**RE: 28 & 34 BELL STREET, KANGAROO POINT
RESPONSE TO COUNCIL INFORMATION REQUEST**

This letter has been prepared by PTT, as requested by HAL Architects, in response to Item 10 in an information request issued by Brisbane City Council (Council), dated 17 July 2026. The development application (Council Reference: A007032991) seeks approval for 18 residential units at 28 and 34 Bell Street, Kangaroo Point.

RCV SERVICING

26-559-003

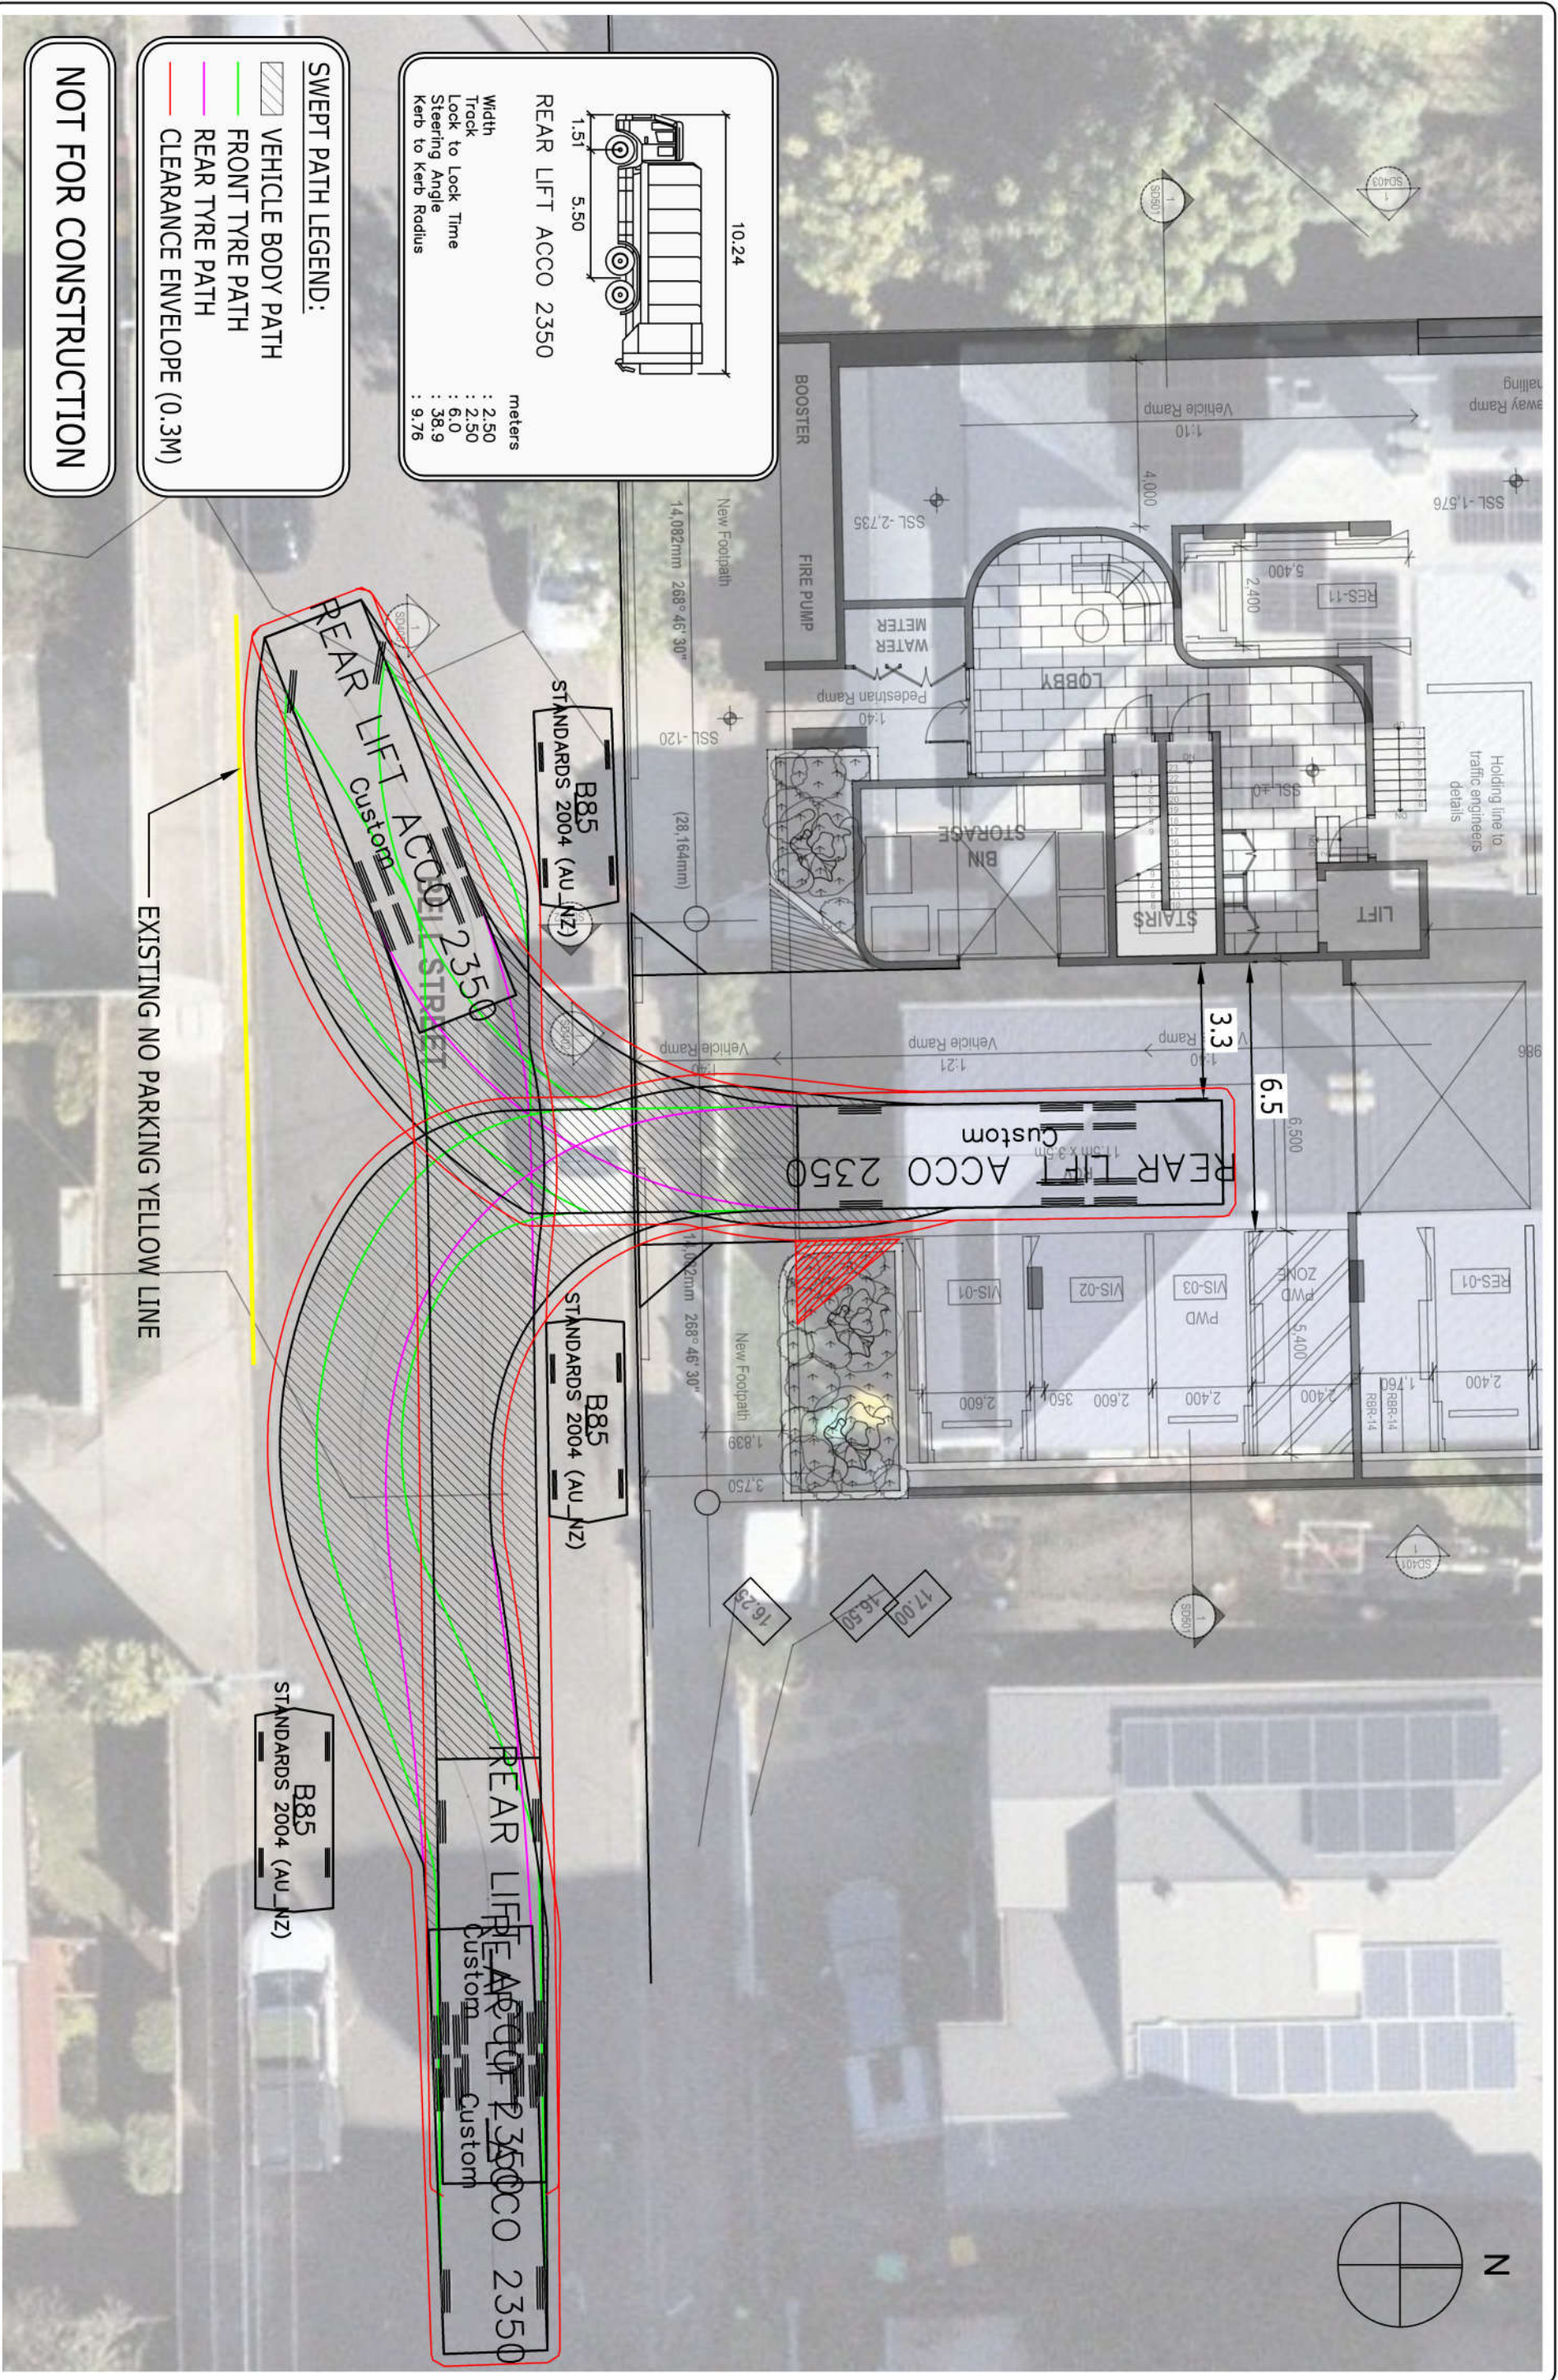
As requested in Item 10 of the information request, a revised swept path of a Council rear-lift Refuse Collection Vehicle has been prepared (see attached) that:

- accords with Council Standard Drawing BSD-3008-2
- adopts a kerb-to-kerb radius of 9.76m and lock to lock time of six seconds
- achieves a minimum 300mm clearance to legally parked vehicles on Bell Street, in proximity to the site access

No additional changes to the site layout and submitted swept paths are considered necessary to demonstrate compliance with Council's City Plan and standard drawing BSD-3008-2.
